STATE OF CONNECTICUT
CONNECTICUT SITING COUNCIL

APPLICATION OF NEW CINGULAR,
WIRELESS PCS, LLC FOR A
CERTIFICATE OF ENVIRONMENTAL
COMPATIBILITY AND PUBLIC NEED
FOR THE CONSTRUCTION,
MAINTENANCE AND OPERATION OF A
TELECOMMUNICATIONS FACILITY AT
95 BALANCE ROCK ROAD, HARTLAND,
CONNECTICUT

DOCKET NO. 408

NEW CINGULAR WIRELESS PCS, LLC ("AT&T")
RESPONSES TO INTERVENOR SIRMAN'S INTERROGATORIES (SET ONE)

EXHIBIT A

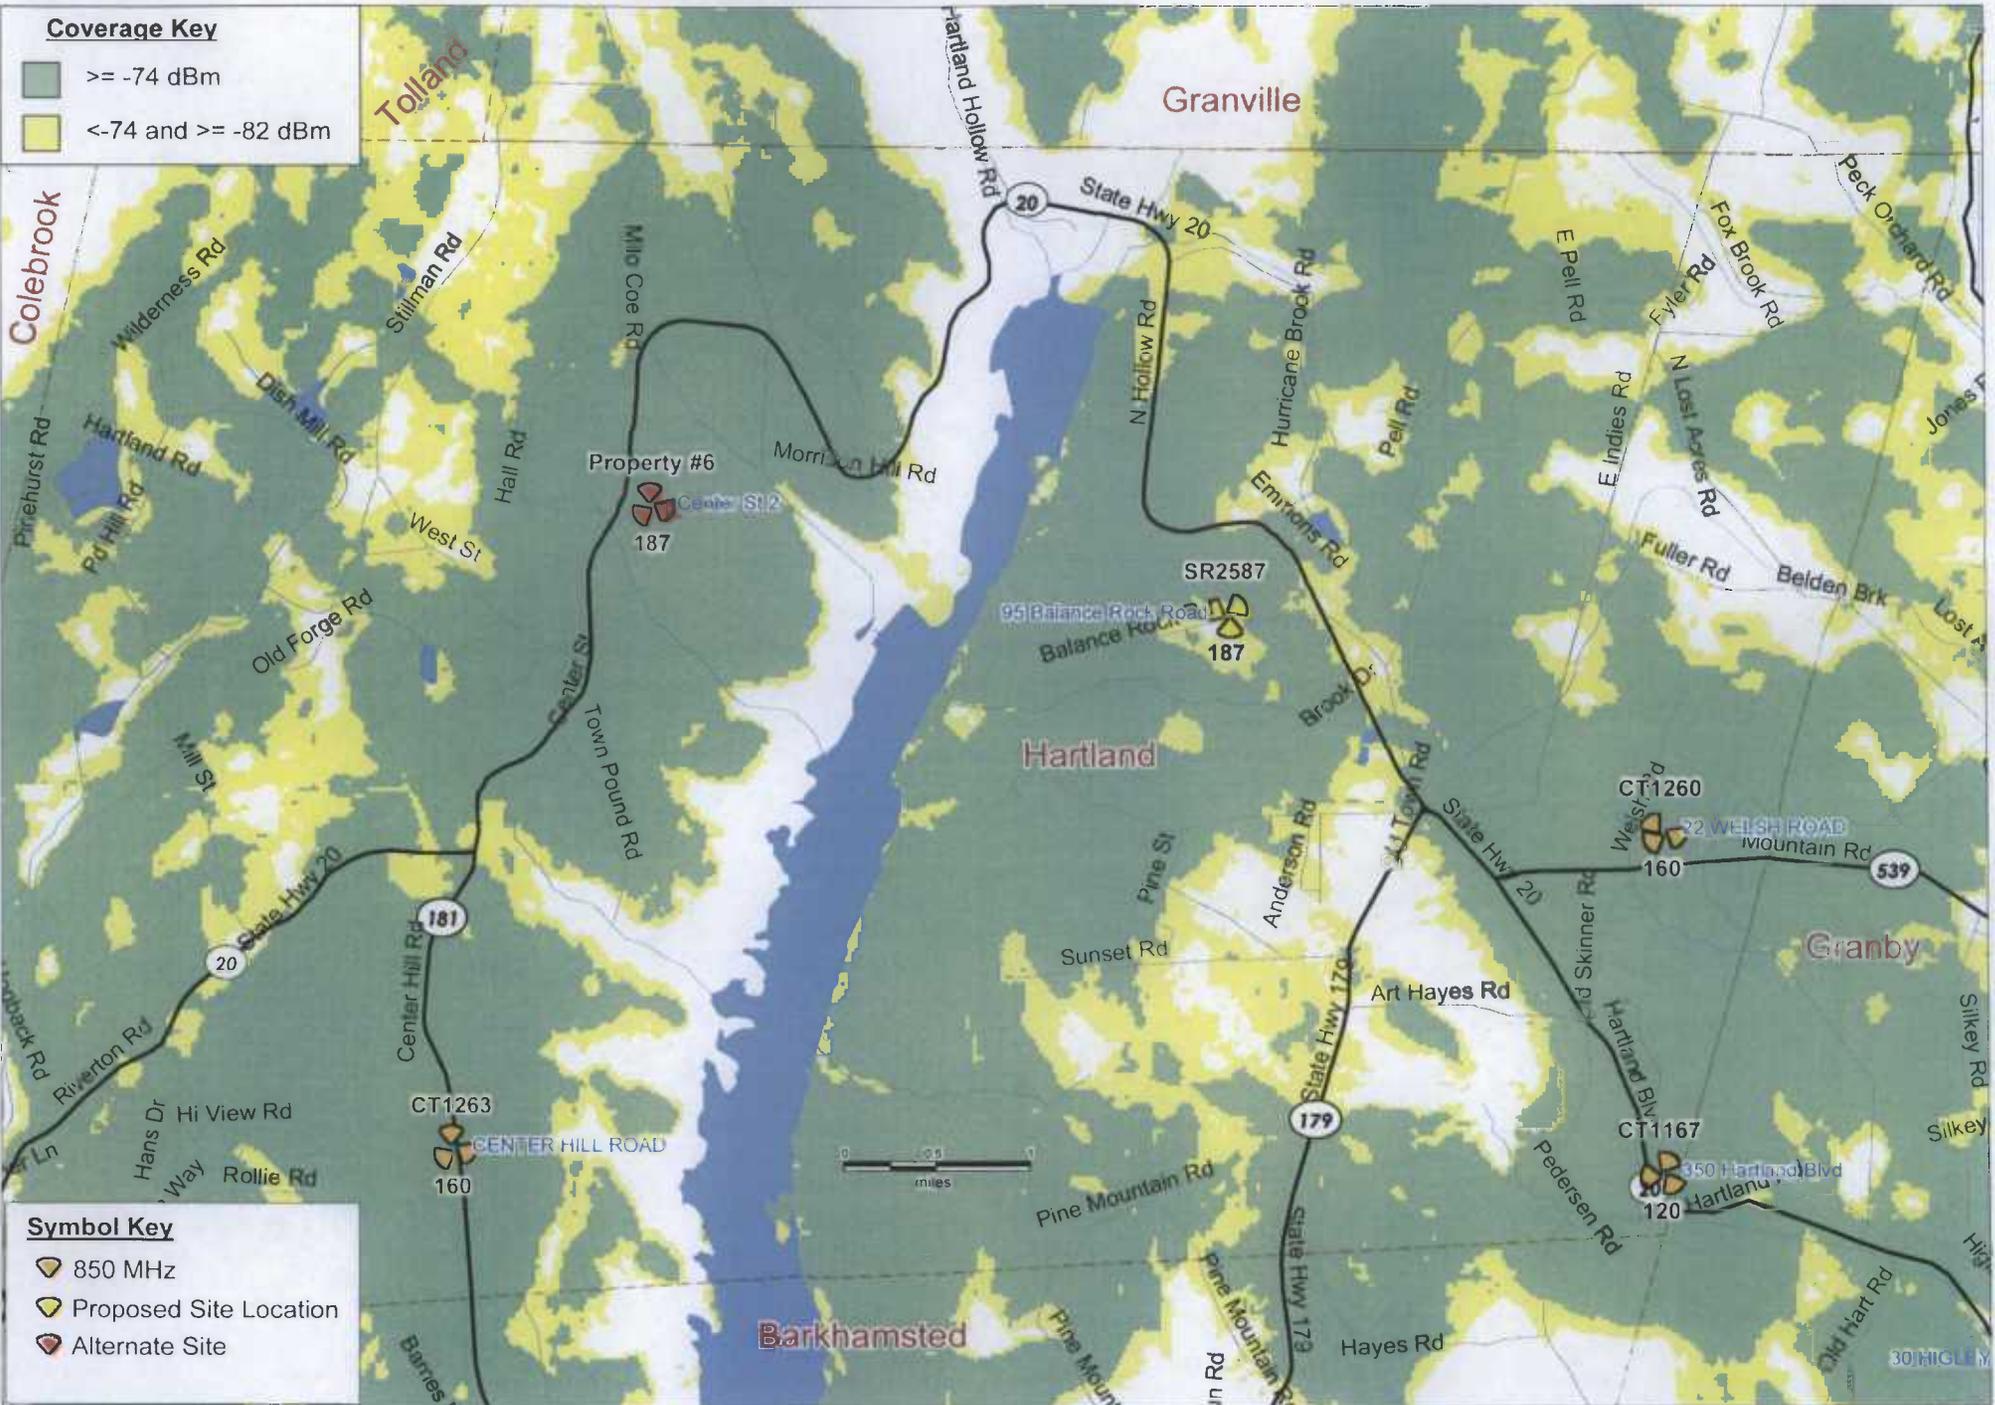
Q2. Why was the property identified as site no. 6 in the site search summary (tab 6 of the application) deemed to be unsuitable as an alternative location for the proposed tower? How did the applicant determine that the entire 40 acre parcel was part of Tunxis State Forest? What use is the State of Connecticut currently making of site no. 6?

A2. Per the Town of Hartland Tax Assessor's records, the property included as site no. 6 in AT&T's Site Search Summary is owned by the State of Connecticut and is part of the Tunxis State Forest. State forest lands are not legally available for tower siting under Connecticut General Statutes and prior determinations of the State of Connecticut Department of Environmental Protection. In addition, that portion of the Tunxis State Forest land which is adjacent to Route 20 is not a technically viable alternative location. A tower facility at this location would not provide adequate service to the area where service is needed. The

propagation map included in Exhibit A demonstrates that even at 190', a tower facility at this location would not provide comparable or adequate service along Route 20.

EXHIBIT B

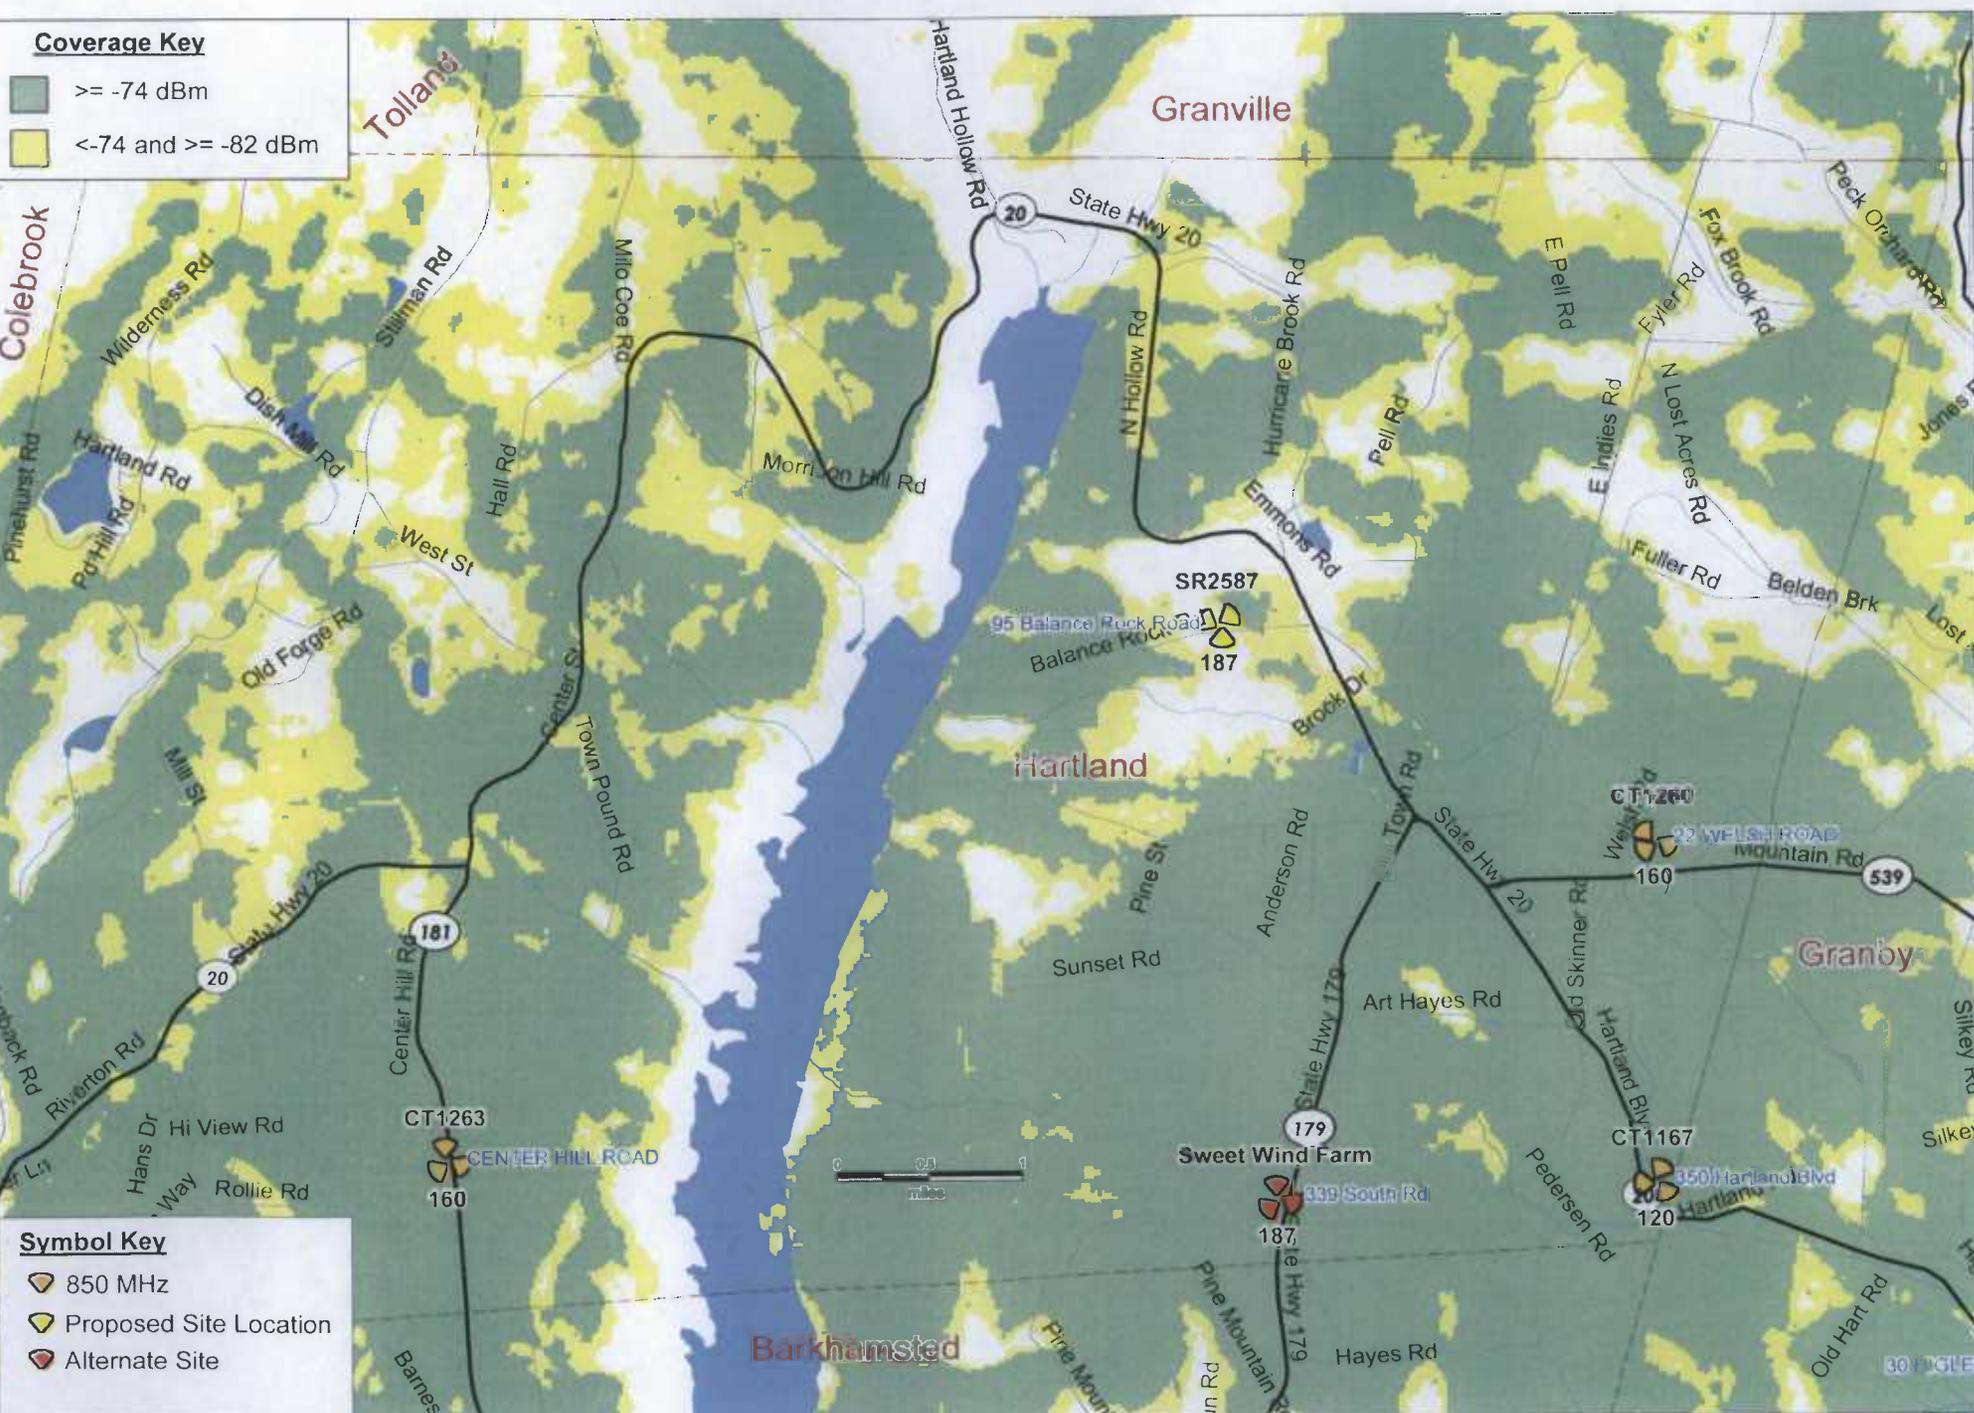
Q3. Have you considered 339 South Road, Hartland or 38 Pell Road, Hartland as alternative locations for the proposed tower?

A3. The property located at 339 South Road was not considered as part of AT&T's initial investigation of potential sites in this area of the State as it is located too far south of the area where service is needed. AT&T's RF engineers subsequently analyzed this location at a height of 190' and confirmed that this location is too far south to provide needed service to Route 20 as demonstrated in the propagation map provided in Exhibit B.

SHEET TITLE
ABUTTERS
MAP

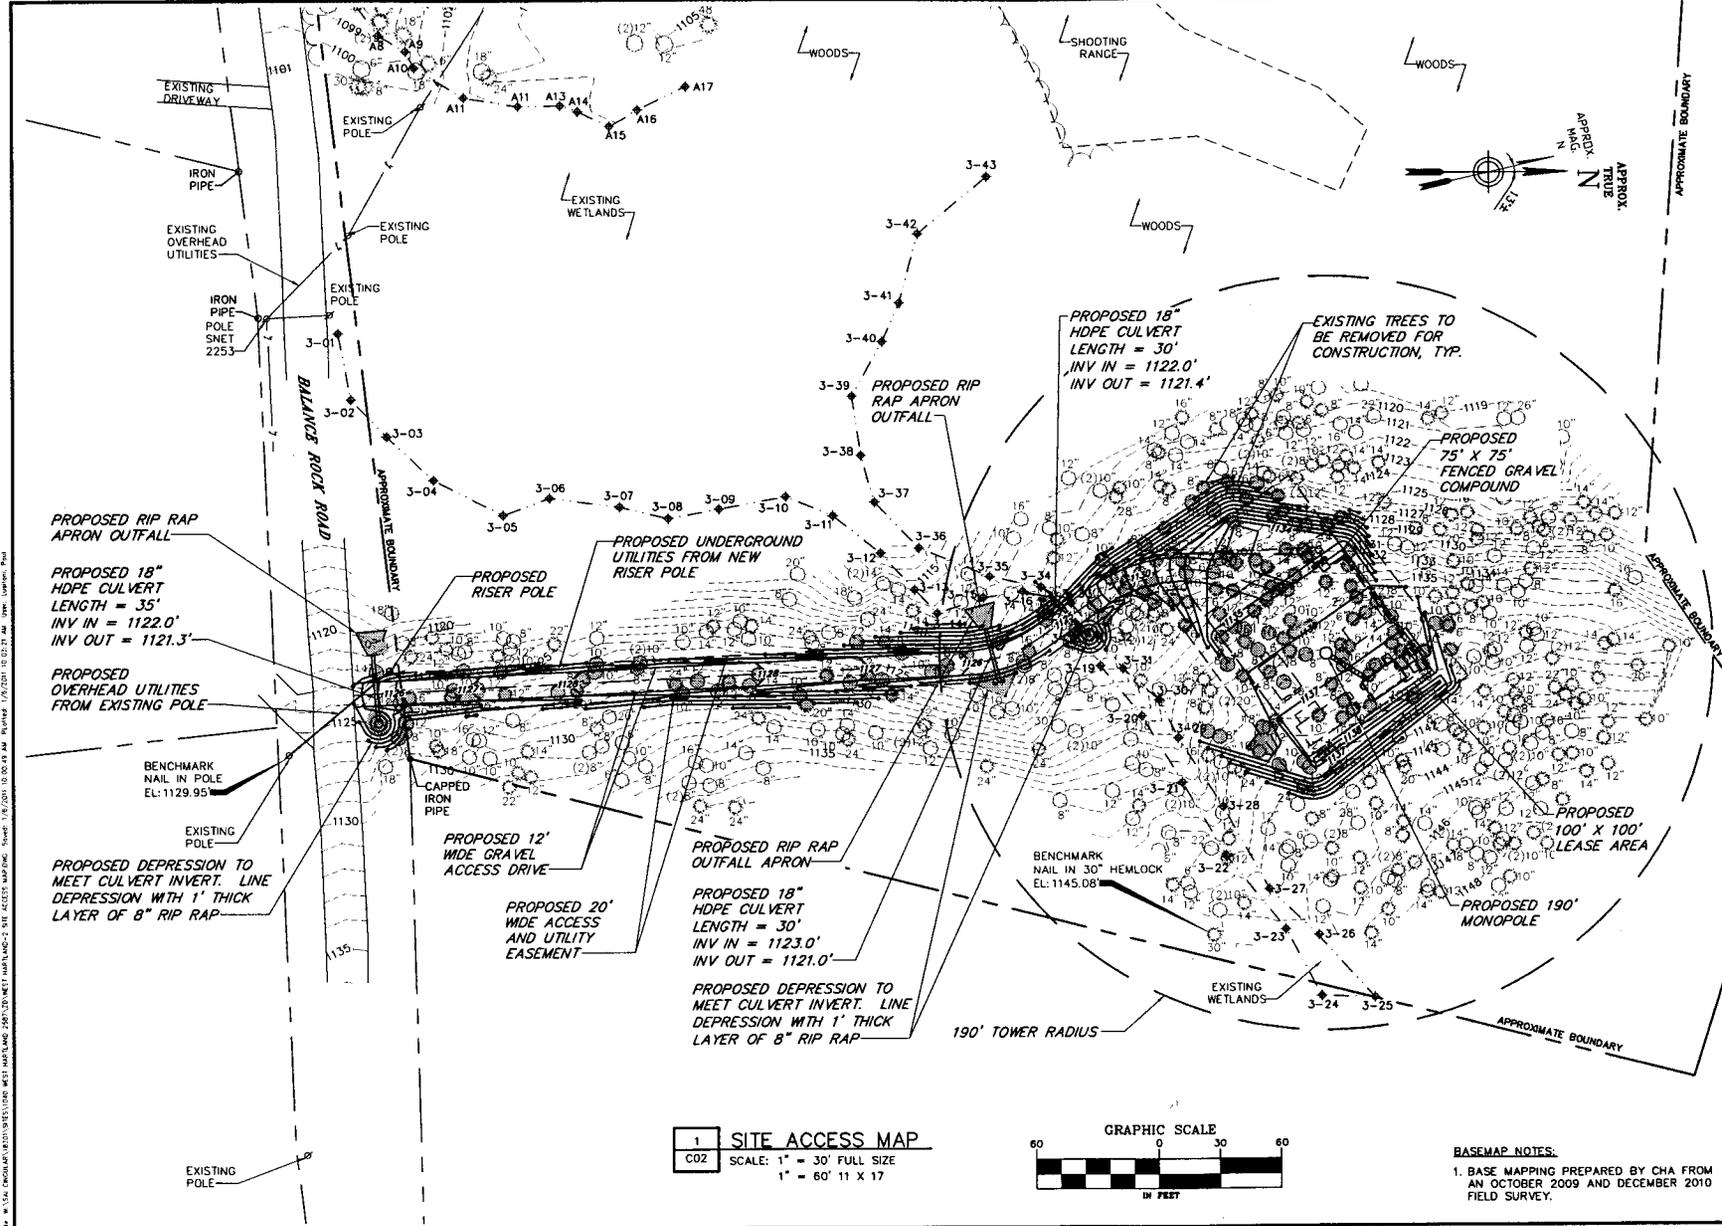
Q9. Did the applicant conduct a survey of the property at 95 Balance Rock Road? Did the applicant conduct a topographic survey of the property at 95 Balance Rock Road? Is any survey available of the property at 95 Balance Rock Road?

A9. Yes. A survey of the property is provided in Attachment 3 of AT&T's Application (Sheet No. C01, Abutters Map) with notes relevant thereto. Attachment 3 also contains a topographic survey within the area of the proposed tower site development. Attached hereto as Exhibit D are drawings and maps detailing the proposed development area for an alternative location on the subject site which is being presented to the Council for its consideration. Also included in Exhibit C are an aerial map, a topographic map, a tree survey and additional data regarding distances for the alternative location on the subject site.
